**RE: Proposed Funding for Arcade-Cripple Creek Trail
 Lead Agency - City of Citrus Heights**

Subject: Re: Arcade-Cripple Creek Trail Project--Sundance Park Bridge

Subject: Arcade-Cripple Creek Trail Project--Sundance Park Bridge
[_____](#)
[_____](#)
[_____](#)

From: Neil Anderson <liennosredna@yahoo.com>
To: Leslie Blomquist <lblomquist@citrusheights.net>
Cc: Peg Pinard <pinardmat@gmail.com>; Tom DiGiacomo <tomagent@tomdigiacomo.com>
Sent: Friday, March 11, 2022, 04:38:48 PM PST
Subject: Arcade-Cripple Creek Trail Project -- Response to Your Letter dated March 8, 2022

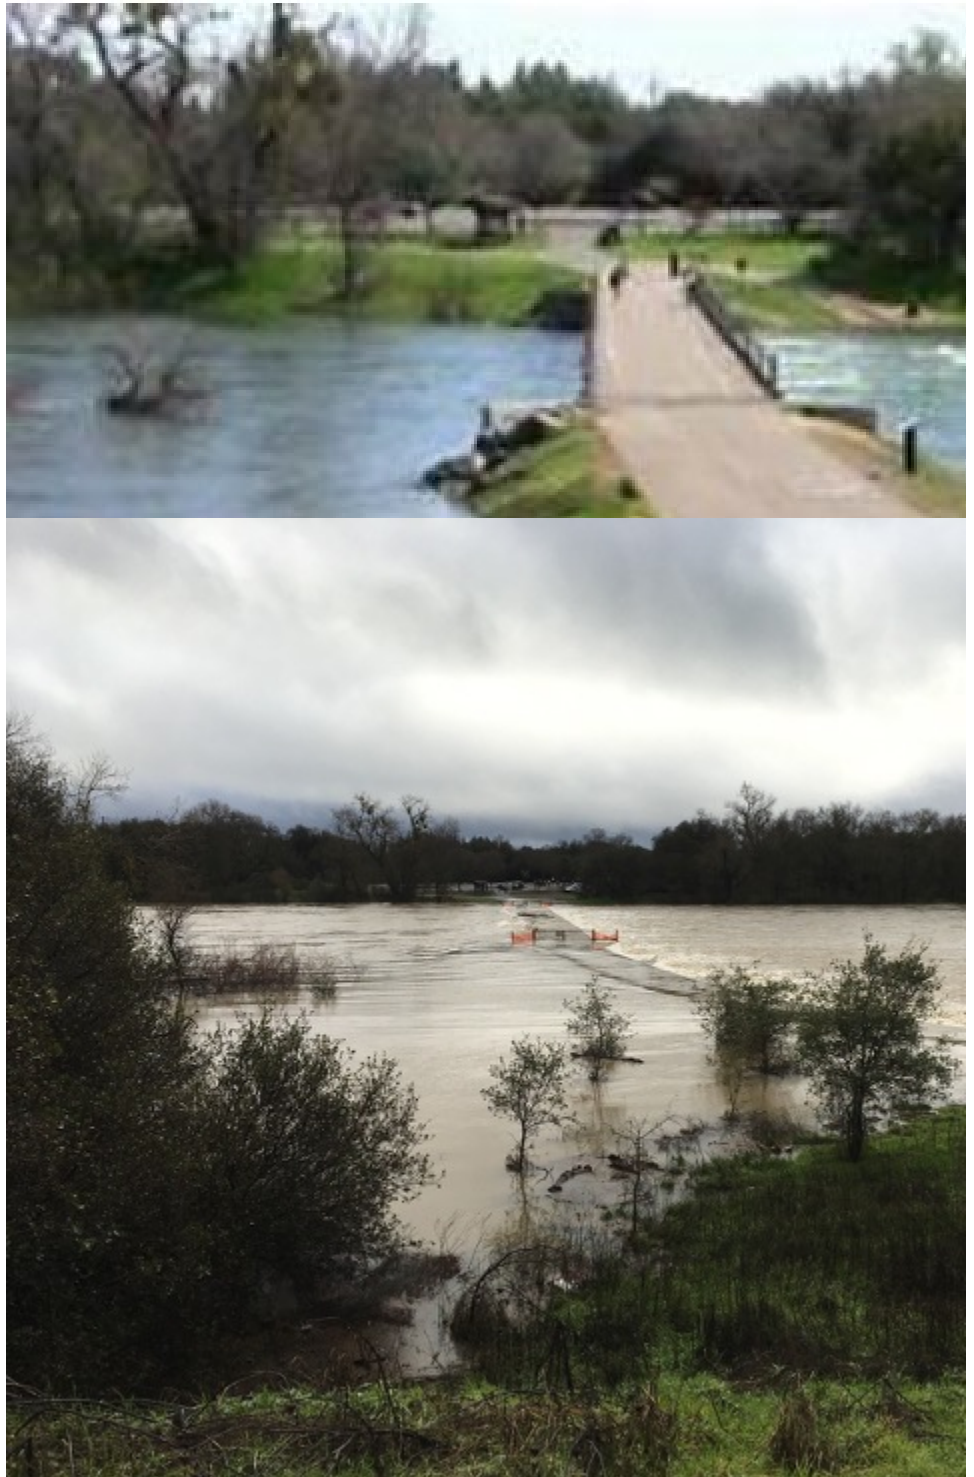
1. FEMA Design Standards: I have requested of City Planning Manager the specific FEMA requirement that an existing pedestrian must be replaced by a new pedestrian bridge. As of March 8, 2022, I have not received a response indicating where I can review this requirement. Considering the scope of FEMA regulations, there doesn't appear to be any requirement that small pedestrian bridges fall under the same FEMA requirements as those concerning major structures. Upon checking with FEMA directly this morning, March 8, about their regulations regarding bridges in general and pedestrian bridges in particular, I was told that they deal primarily with disaster relief. They said that bridges "would only become important in providing access to an area that suffered flood damage". The Sundance Natural Area is a relatively small parcel of land that is a flood plain and a recharge area for our aquifer. In the event of a 100 yr. flood access to all structures are accessible by paved roads from multiple directions. The City's response to FAQ #35 on the its webpage referring to the existing bridge not meeting FEMA requirements is misleading.

2. ADA Accessibility: According to the City of Citrus Heights, the existing bridge has been categorized as not meeting the latest ADA standards because the floor board spacing is too great and that the bridge does not have guardrails. The bridge can be brought into ADA compliance without raising it. The existing timber bridge deck can be replaced with a surface compatible with wheelchairs and guardrails can be added to each side of the existing bridge. The guardrails can be designed to be readily removable. This bridge does not have to be removed in its entirety and replaced by

a new bridge in order to comply with
ADA.

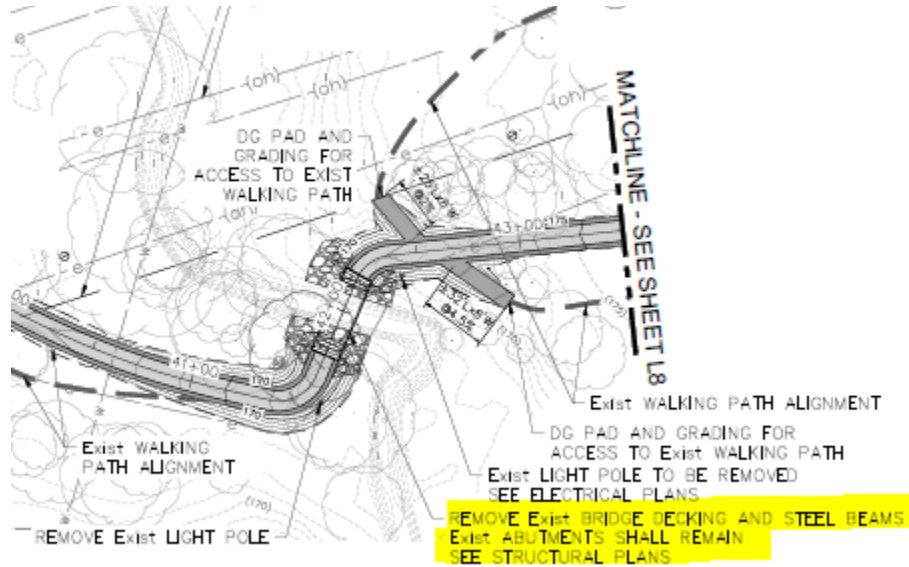
3. The replacement of the bridge deck with metal grating and the addition of removable guardrails will not add to the obstruction that already exists. The submerged volumes of these items (grating and guardrail post support brackets) will be very small and raise the floodwater surface elevation an insignificant amount. Ramps for the new elevated bridge will add volume and raise the floodwater surface elevation. The existing abutments being left in place will also obstruct the flow. Other measures can be considered in order to lessen the impediments to the stream flow.
